Invitation for Bid# 2021-051
853W Zone Improvements – Phase 1 Transmission Mains
Rocky River Road & Secret Shortcut Road

ADDENDUM No. 1

853W Zone Improvements – Phase 1 Transmission Mains Rocky River Road & Secret Shortcut Road
Black & Veatch Project # 186110

ADDENDUM NUMBER 1

CIVIL
PLAN AND PROFILE
STA 80+00 TO STA 90+00

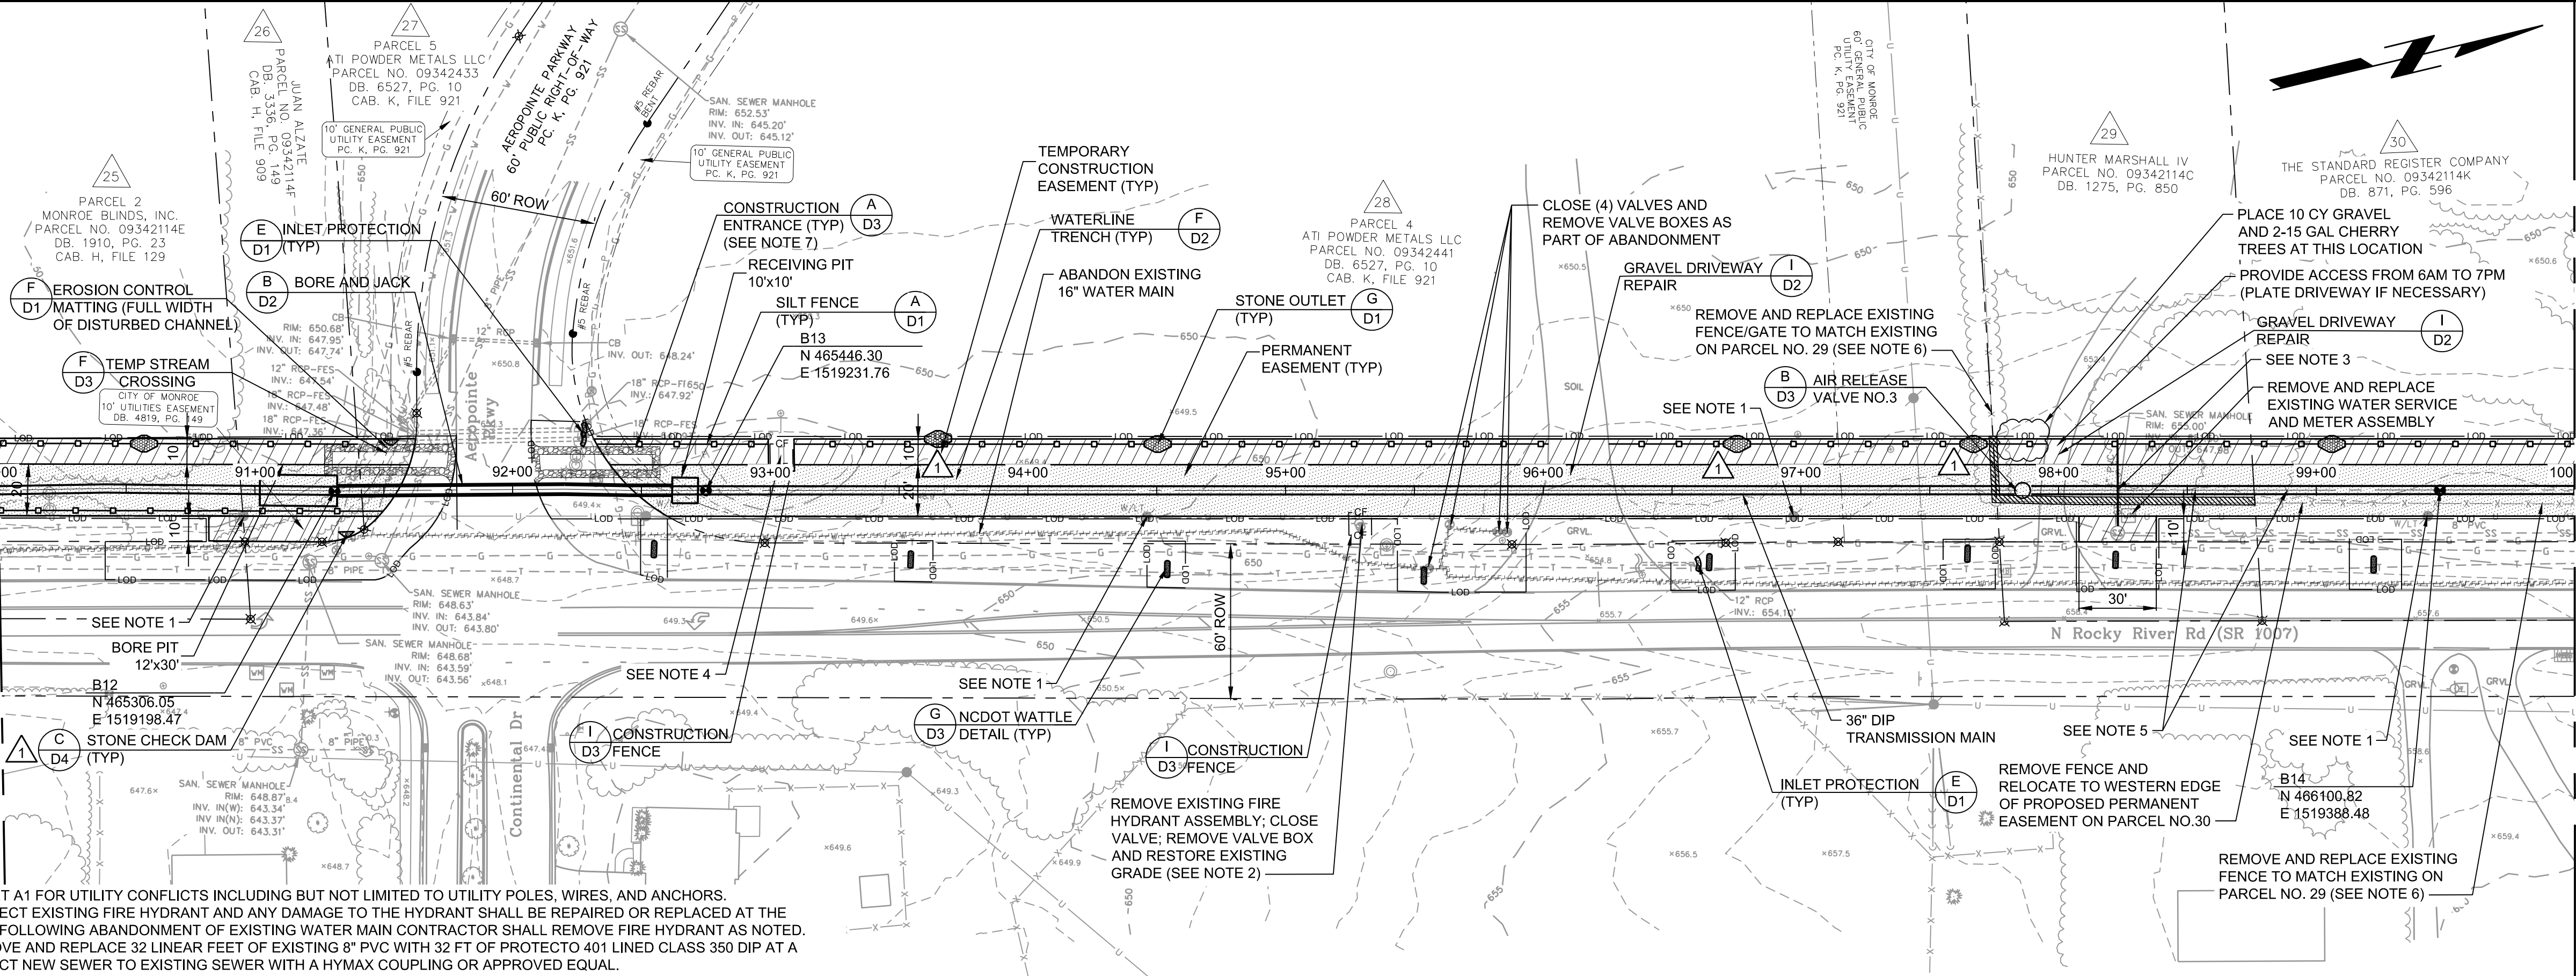
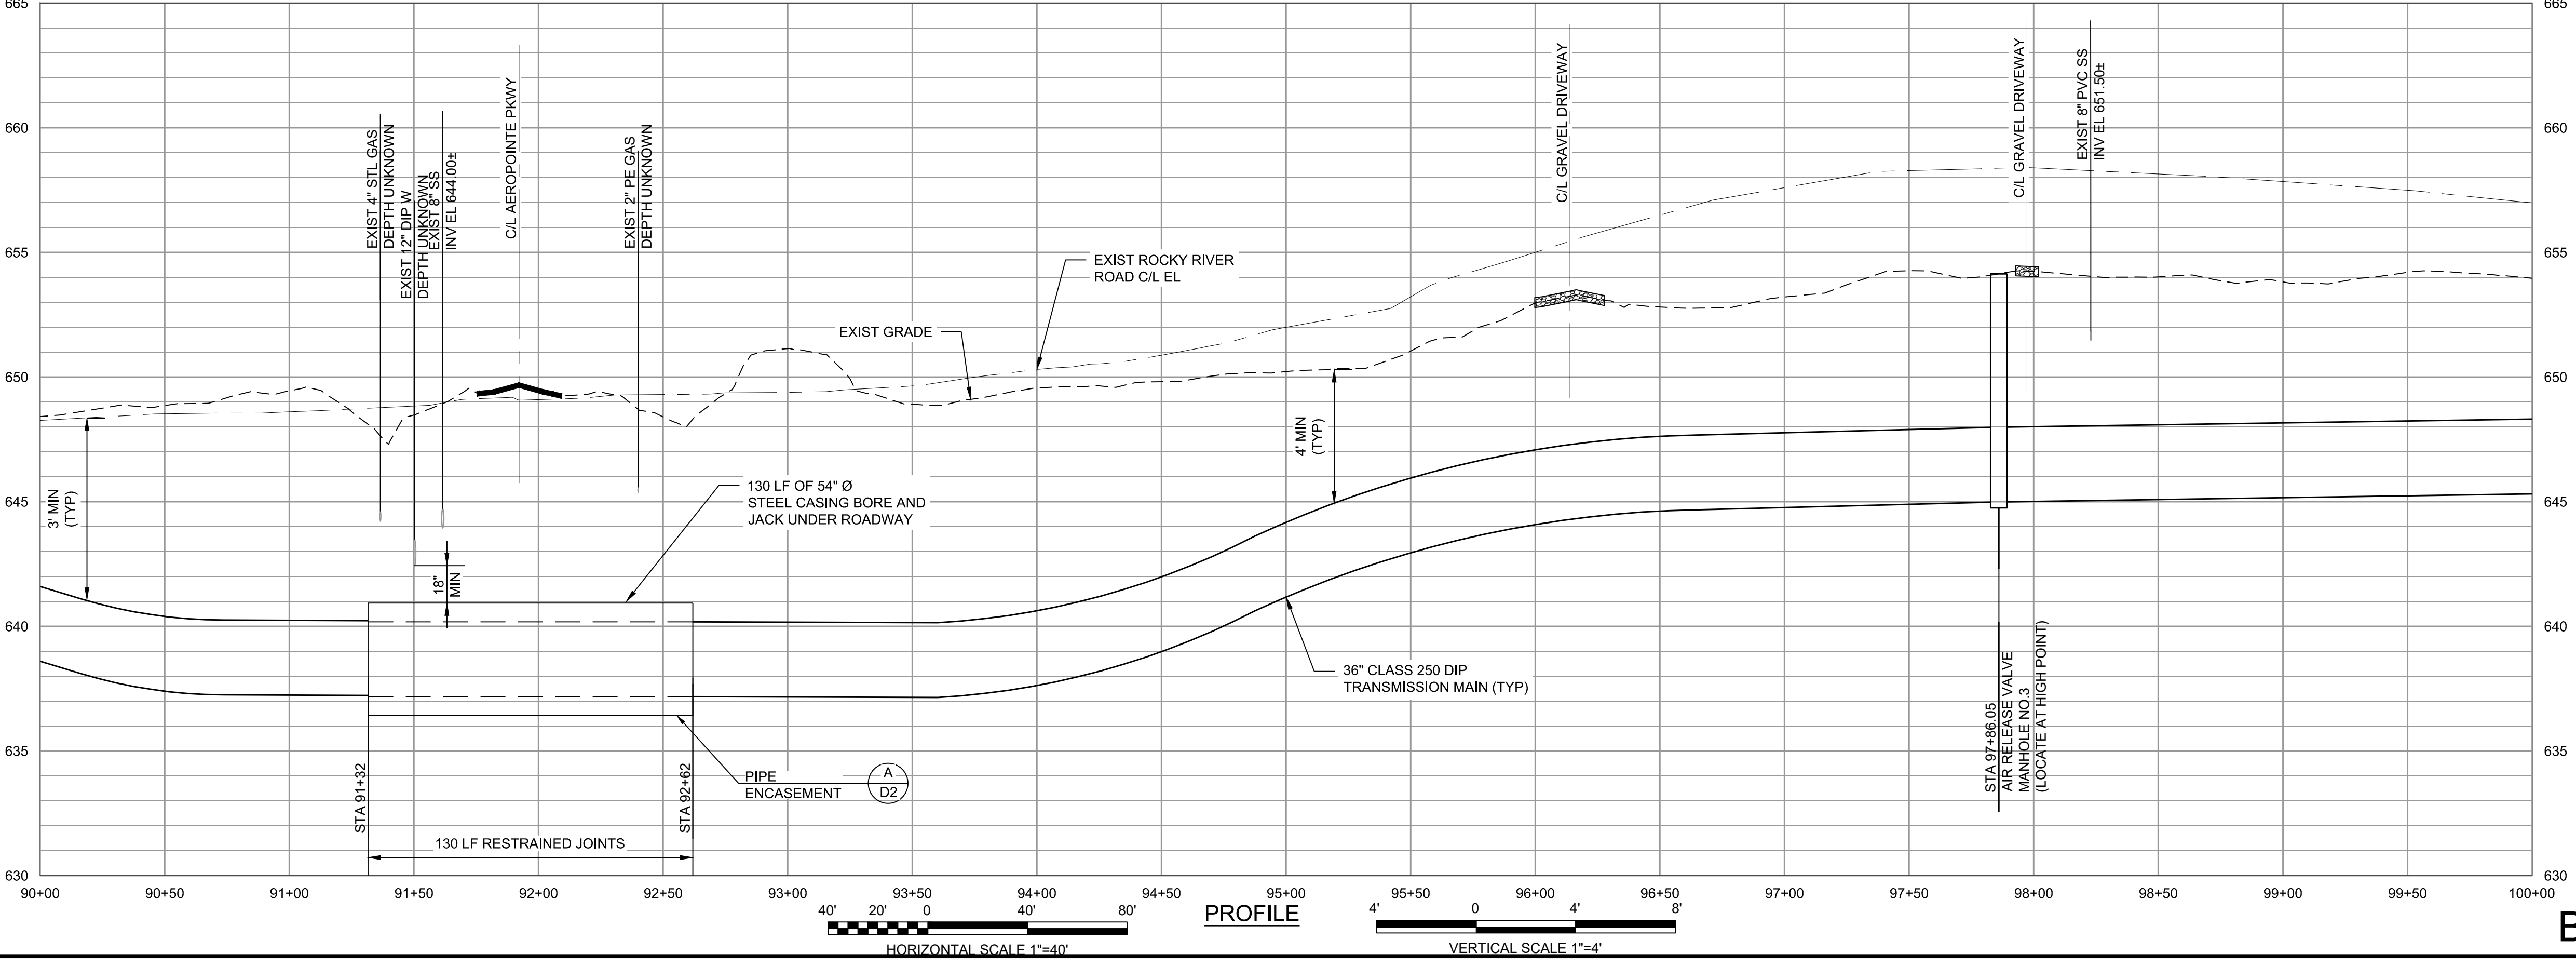
- CONTRACTOR SHALL LIMIT ALL WORK TO OUTSIDE STORMWATER BMP.
 - CONCRETE ENCASE PIPELINE FROM STA 85+10 TO STA 88+00 PER DETAIL H ON SHEET D1. NO GRANULAR EMBEDMENT SHALL BE USED IN THIS AREA. PIPELINE SHALL BE CONSTRUCTED WHEN STORMWATER BMP IS DRY. PROVIDE EROSION CONTROL MATTING FOR THE FULL WIDTH OF THE DISTURBED AREA FROM STA 85+10 TO STA 88+00 AND COMPACT ANY DISTURBED PORTION OF THE STORMWATER BMP BERM TO 95%.

CIVIL
 PLAN AND PROFILE
 STA 131+00 TO STA 140+00

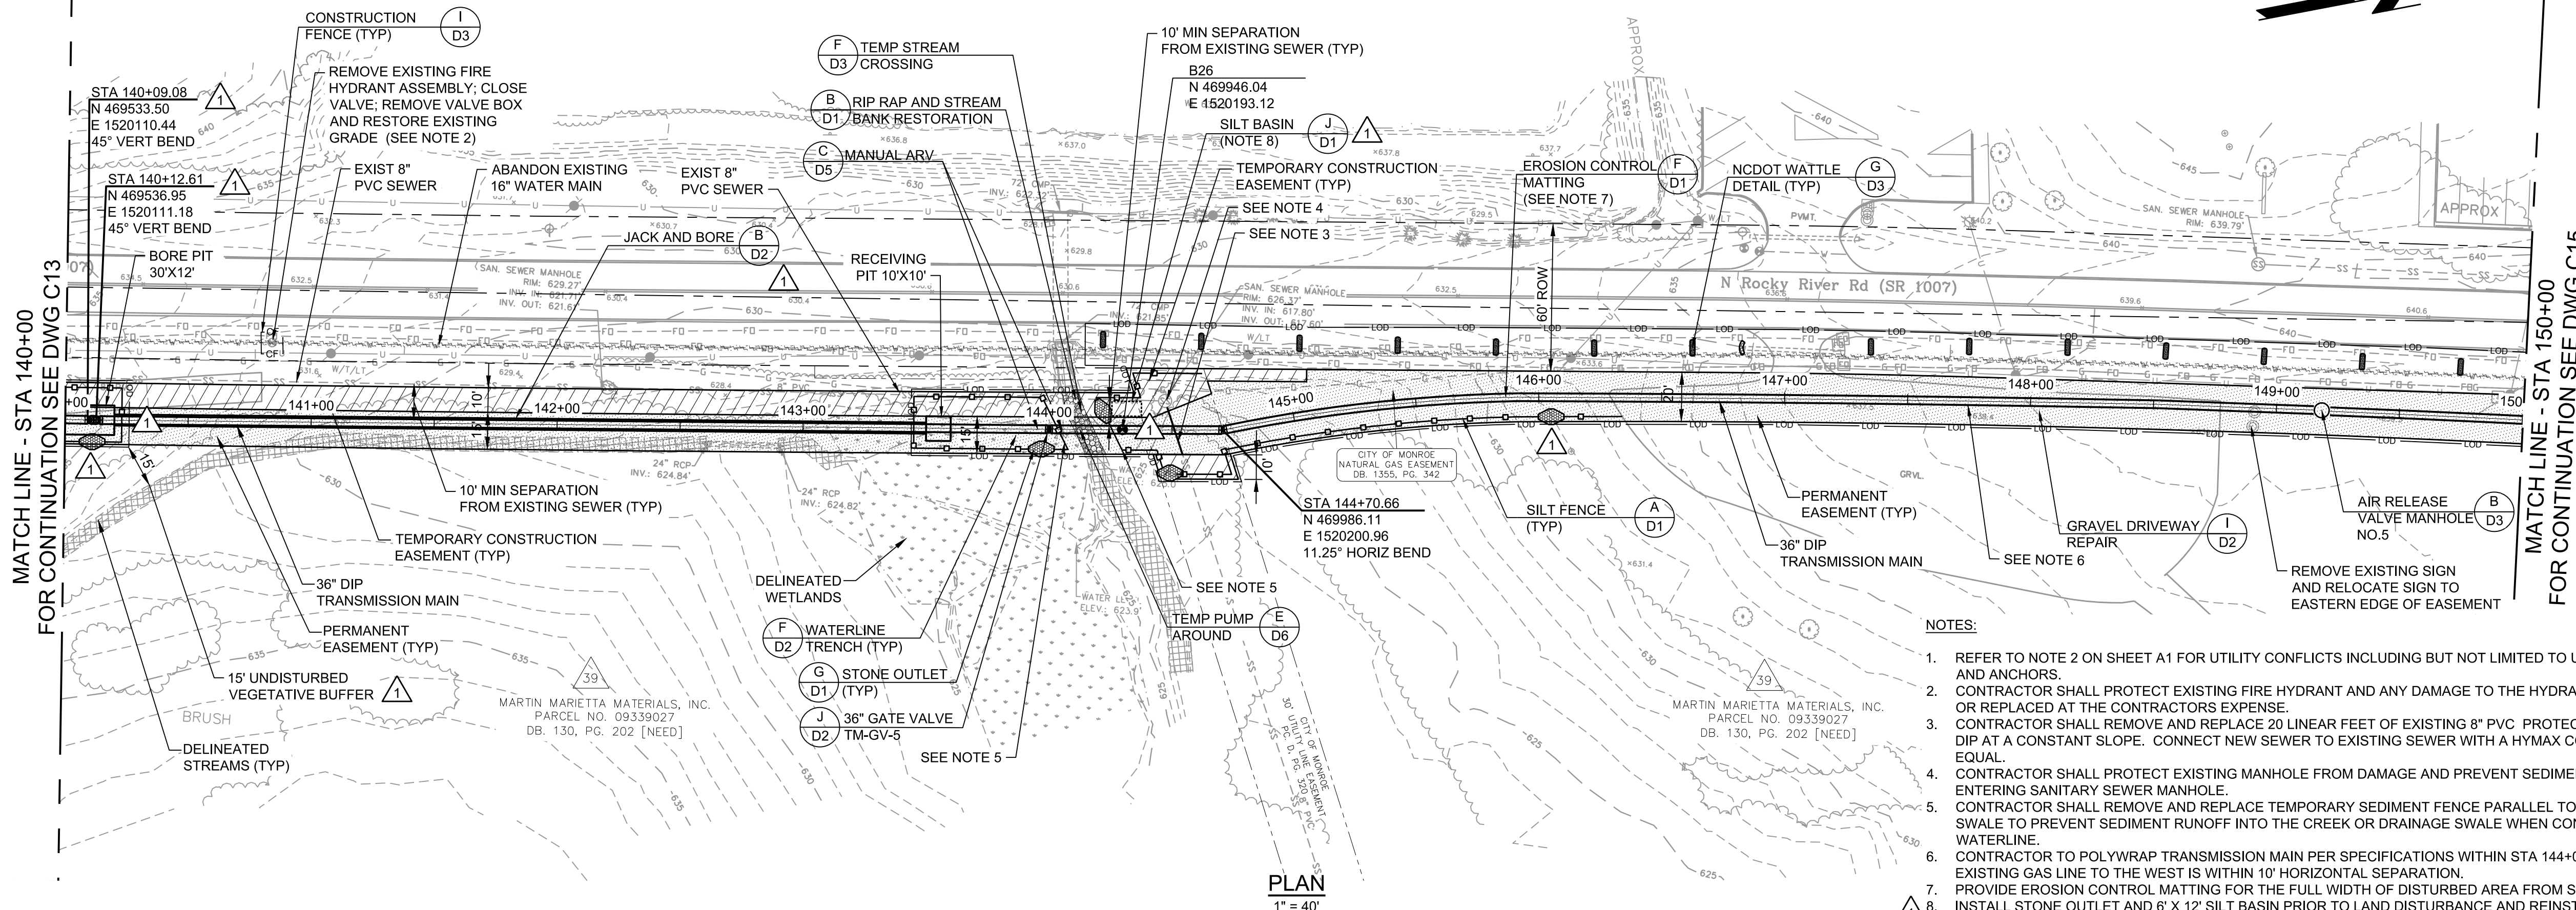
36. There are inconsistencies between the bend angle shown on plan and profile views between Sta. 136+37 and 138+02. Please advise.
The bends between the stations have been revised in the attached Drawing C13 to reflect the correct bend angles.
